AC-26-11

SP-2026-00065 (Appeal)
SIGN-2025-00304 (Building Safety – Sign Permit)

MEMO

Subject: AC-26-11, SIGN-2025-00304: Lindmark Companies ("Applicant") appeals the Planning staff's decision to DENY a sign permit for a billboard conversion to a digital billboard for the property located at 5801 Gibson Blvd SE, zoned MX-M.

10'x30' Tri-vision Three (3) Faces
James Spence
940.867.1467

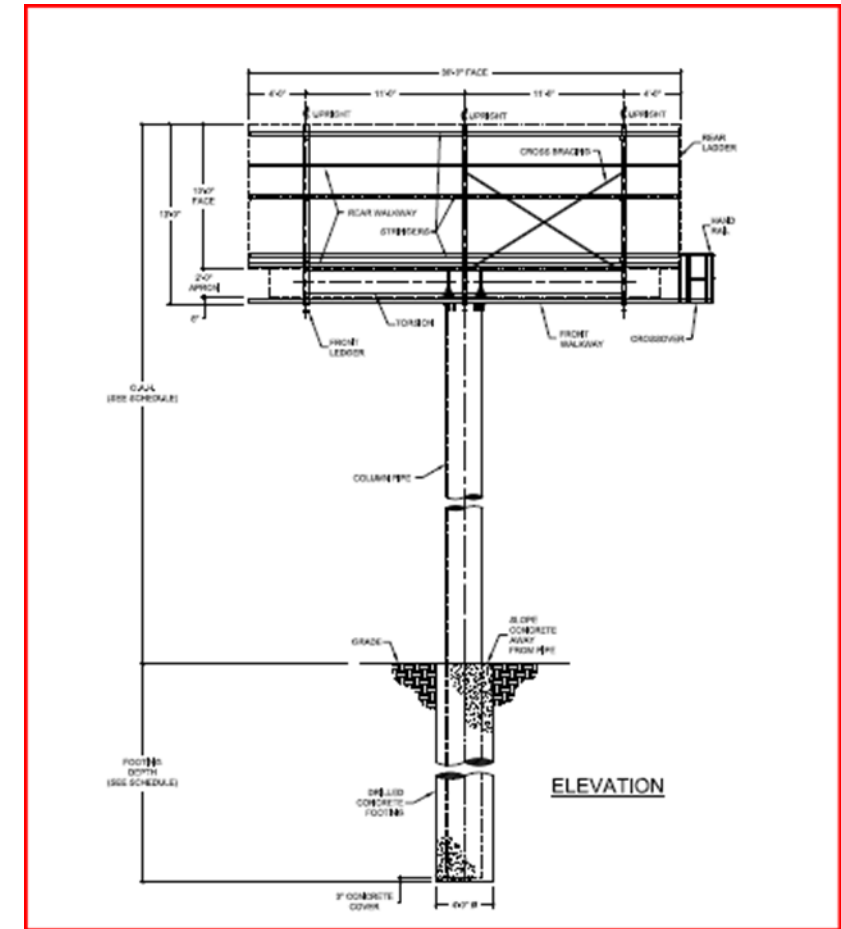
Zoning - Cap and Replace Off-Premise Sign Removal Application is incorrect in citing the existing sign in the same location towards the removal credit. For a sign to be counted as "removed advertising space," it must be removed and not replaced, as per IDO 5-12(H)(3)(b)(4). Both the sign and its support structure must be permanently removed, as per IDO 5-12(H)(3)(b)(2). JPalmer
